VIRGINIA
DIVISION OF HISTORIC LANDMARKS
HISTORIC DISTRICT/BRIEF
SURVEY FORM

Figure 35: Proposed Manassas Bypass, Southern Section Showing Lake Jackson and Lake Jackson House (76-72)

Re: Proposed Manassas Bypass
Prince William County
FHWA-VA-EIS-79-03-DS
VDOT Project No. 6234-076-F11, PE101
VDHR File No. 90-0911-F

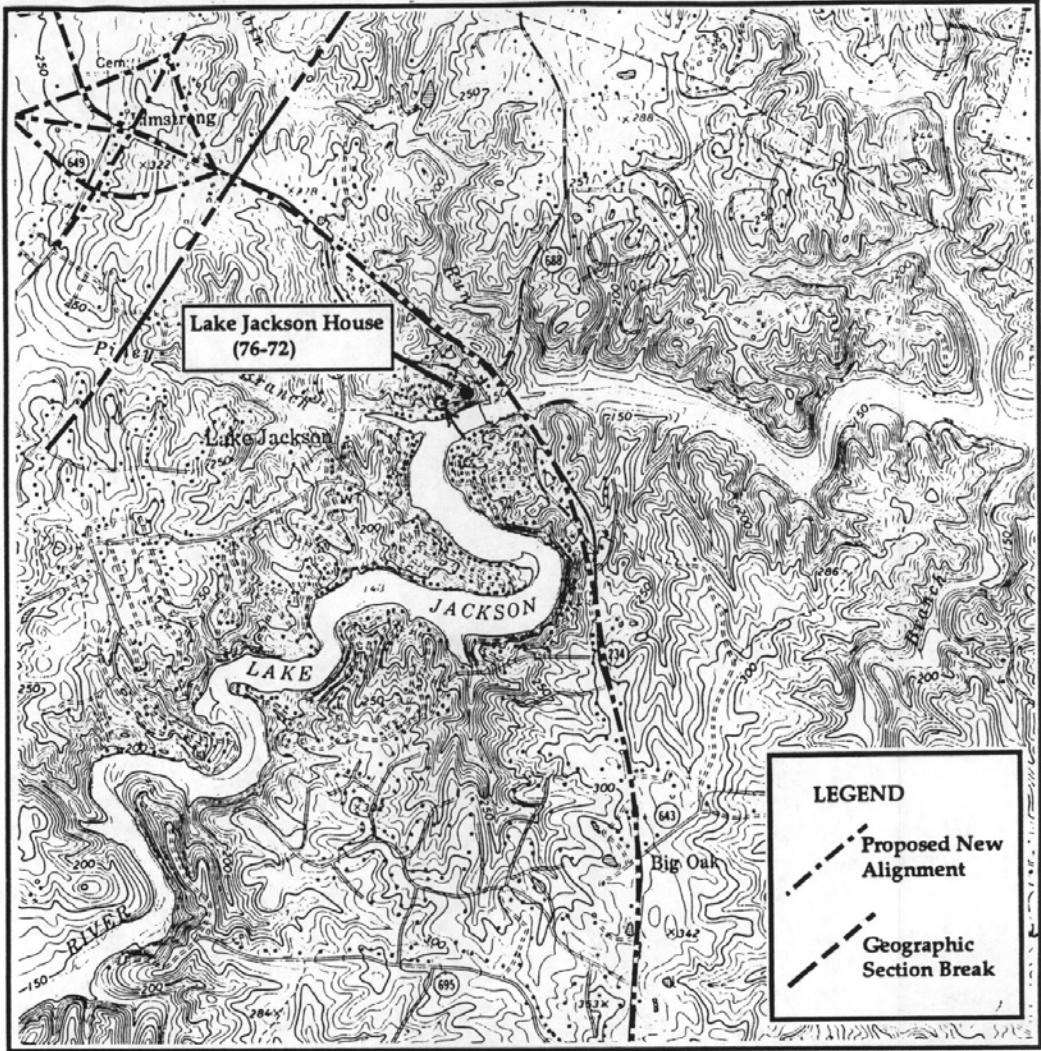
We concur with your consultant's determination that the undertaking will have an adverse effect on the following historic properties: Bloom Hill (76-149), Bradley (76-70), the Lake Jackson Historic District (76-390), and the Manassas Battlefield. Resources affected on the Manassas Battlefield include The Manassas National Battlefield Park (76-271), Pageland I (76-138), and Pageland II (76-137).

We appreciate the efforts made at this stage of environmental analysis to reduce the adverse effects on Bradley, Bloom Hill, Pageland I, and Pageland II. We encourage your agency and the FHWA, however, to reconsider the following project alternatives which, in our opinion, would eliminate the adverse effects of the undertaking on historic properties. We urge that the interchanges with Routes 649 and 673 be eliminated or relocated

elsewhere. Such an alternative would eliminate the adverse effect at Bradley and would reduce the adverse effect at Bloom Hill below the level advocated in the DSEIS. For the Manassas Battlefield area, we recommend that Alternative 3 be reconsidered which would terminate the project at I-66 and would avoid most of the resources on the battlefield (including Pageland I, Pageland II, and the Manassas National Battlefield Park). Reconsideration of Alternative 3 should also include comparison to a modified Selected Alternative which would include closure of existing Route 234 through the park to partially mitigate the effect of the undertaking on that historic property.
